# UNITED STATES PATENT AND TRADEMARK OFFICE

10/550,279

| <b>Office Action Summary</b> | <b>Application No.</b><br>10/550,279 | <b>Applicant(s)</b><br>SPAGGIARI, ALESSANDRO |  |

**DETAILED ACTION**

**Fig. 1 and Fig. 2 of United States Patent No. 3,303,995 (Boeckel hereinafter)**

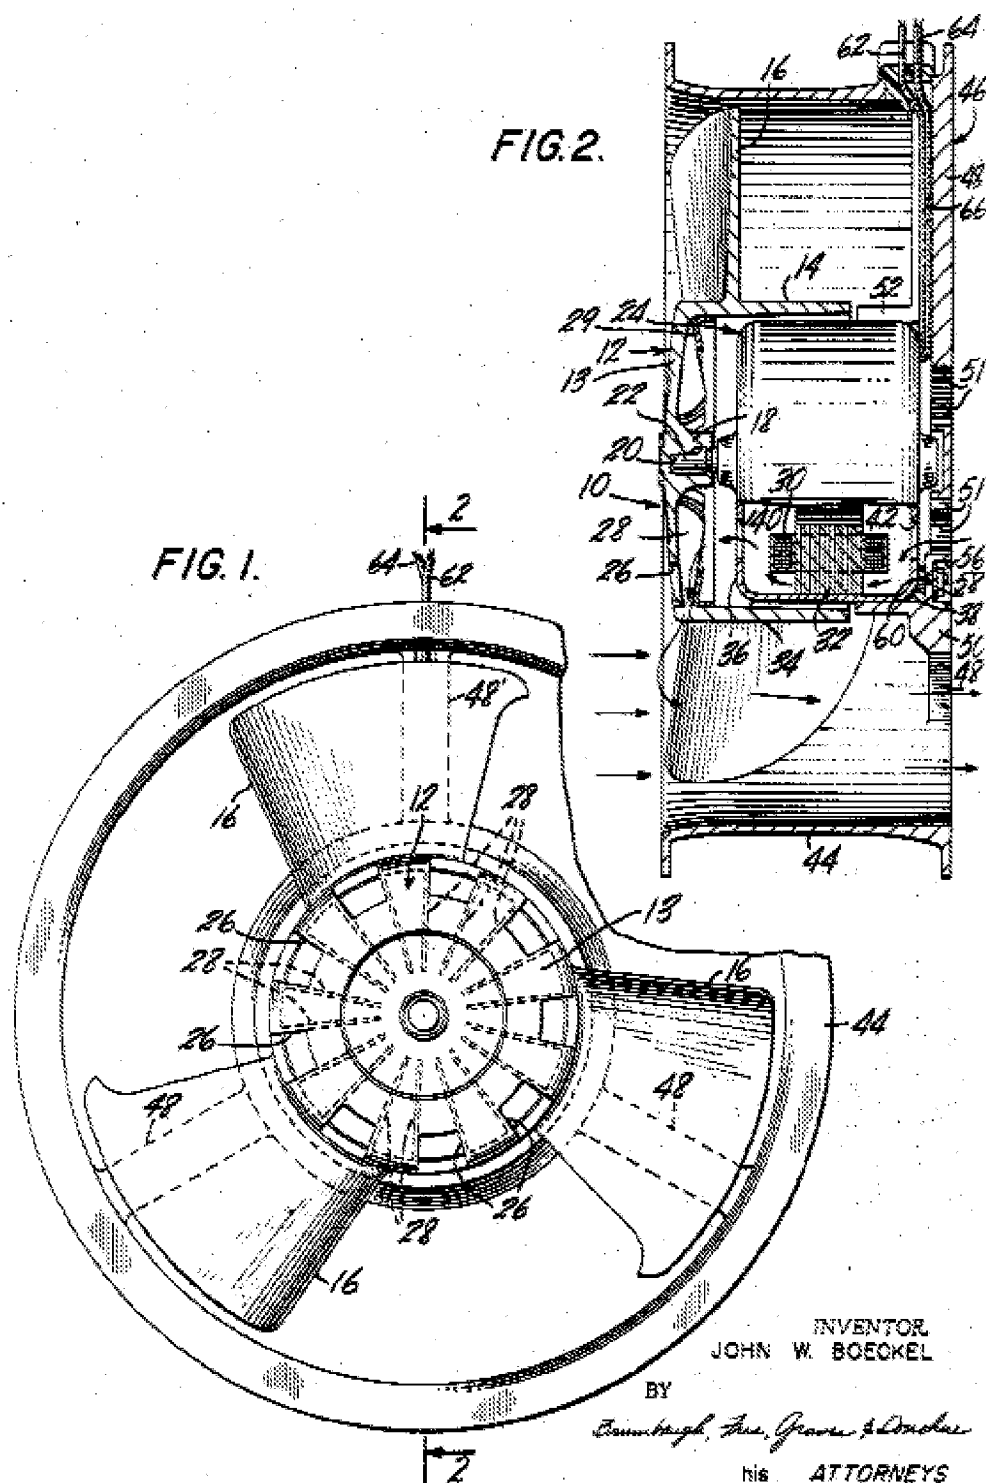
2. Claims 1, 2 and 4-7 are rejected under 35 U.S.C. 102(b) as being anticipated by US PAT 3,303,995 (Boeckel hereinafter)

- In re Claim 1, Boeckel discloses (see Fig.'s 1 and 2 above):

An axial fan in which an impeller comprises a hub (12), motor-powered so that it rotates about its own central axis in a predetermined direction of rotation, and a plurality of blades (16) extending from the hub (12) in directions transversal to the axis; the hub (12) having a cup shape and being formed by a bottom wall (13) and a ring-shaped side wall (14); the bottom wall (13) having a plurality of long ribs (28) arranged in a radial direction and extending in height towards the hub (12) cavity, each of the ribs (28) abutting on an internal face of the ring-shaped side wall (14) and delimiting, together with said ring-shaped side wall (14), a corner area of the bottom wall (13) positioned in front of the rib (28) with reference to the direction of rotation; the fan being characterised in that each corner area has a through-hole (26) for discharging any debris, in particular water, sand, soil or sludge, from the hub (12) cavity to the outside of the hub (12).

- In re Claim 2 Boeckel discloses (see Fig.'s 1 and 2 above):

The fan according to claim 1, characterised in that the through-holes (26) are evenly distributed along a circle centred on the axis and close to the ring-shaped side wall (14).

- In re Claim 4 Boeckel discloses (see Fig.'s 1 and 2 above):

The fan according to any of the foregoing claims, characterised in that in each of the said corner areas a through-hole (26) is delimited by at least three walls, of which a first wall substantially acts as an extension of the ring-shaped side wall (14).

- In re Claim 5 Boeckel discloses (see Fig.'s 1 and 2 above):

The fan according to any of the foregoing claims, characterised in that in each corner area a through-hole (26) is delimited by at least three walls, of which a second wall substantially acts as an extension of the rib (28).

- In re Claim 6 Boeckel discloses (see Fig.'s 1 and 2 above):

The fan according to any of the foregoing claims, characterised in that, with reference to the direction of the axis and to the direction of rotation of the hub (12), each through-hole (26) is delimited by at least three walls, of which a first flat external wall lies in a plane at a right angle to a radial direction and to the bottom wall (13).

- In re Claim 7 Boeckel discloses (see Fig.'s 1 and 2 above):

The fan according to any of the foregoing claims, characterised in that, with reference to the direction of the axis and to the direction of rotation of the hub (12), each through-hole (26) is delimited by at least three walls, of which a second flat rear wall lies in a plane parallel with a radial direction and is angled backwards by a predetermined angle relative to the direction of the axis.

**Figure 5 of FR 2,815,676 A (Gassmann hereinafter)**

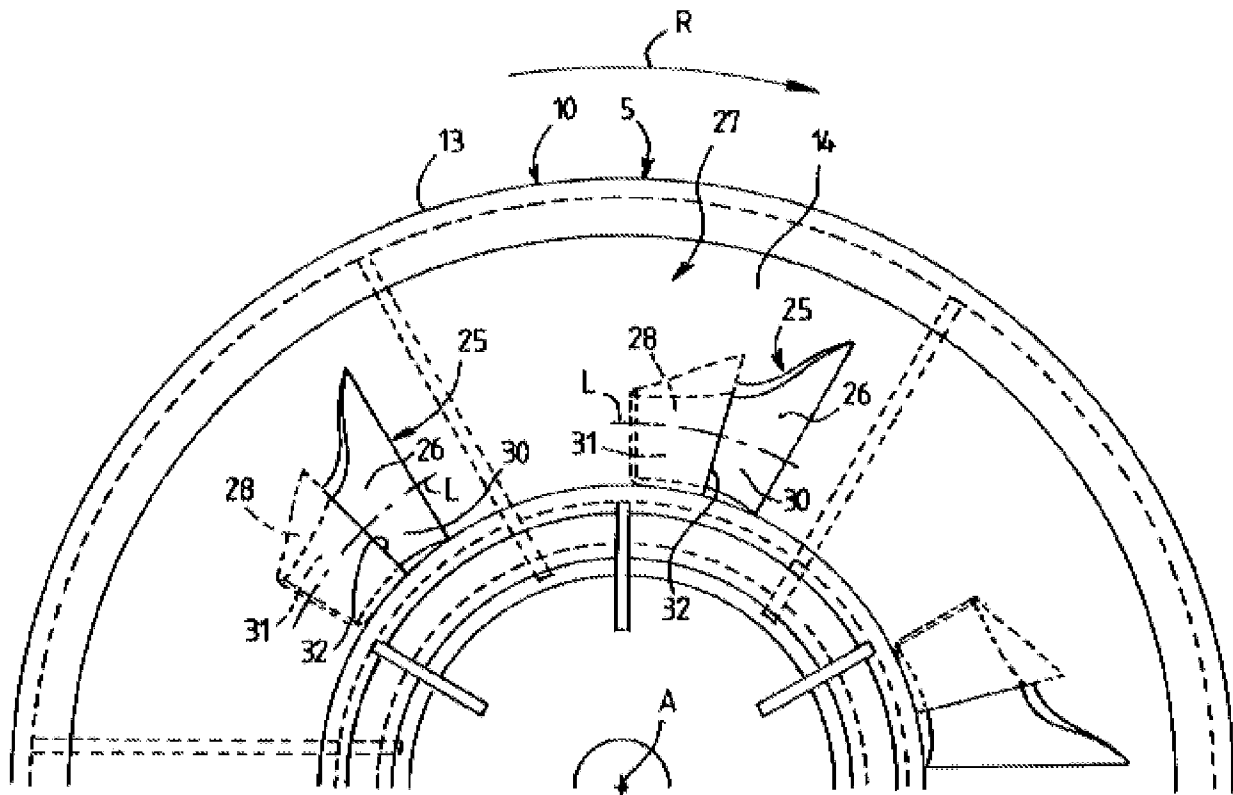
Claims 3 and 8-11 are rejected under 35 U.S.C. 103(a) as being unpatentable over Boeckel in view of FR 2,815,676 A (Gassmann hereinafter). In regard to Claims 3 and 8-11, Boeckel (US PAT 3,303,995) discloses the invention substantially as claimed but does not disclose "...a third flat internal wall lies in an oblique plane relative to a radial direction and at a right angle to the bottom wall." Boeckel also fails to disclose "the through-holes have a substantially triangular prismatic shape." Gassmann, in reference to Fig. 5 above, discloses through-holes that are not quadrilateral (Boeckel

discloses quadrilateral holes). Not all walls of said (Gassmann) through-holes are perpendicular to the bottom wall. Therefore, it would have been obvious to one having ordinary skill in the art at the time the invention was made to employ a through-hole with a substantially triangular prismatic shape with a wall/walls that is/are oblique to the radial direction as taught by Gassmann.
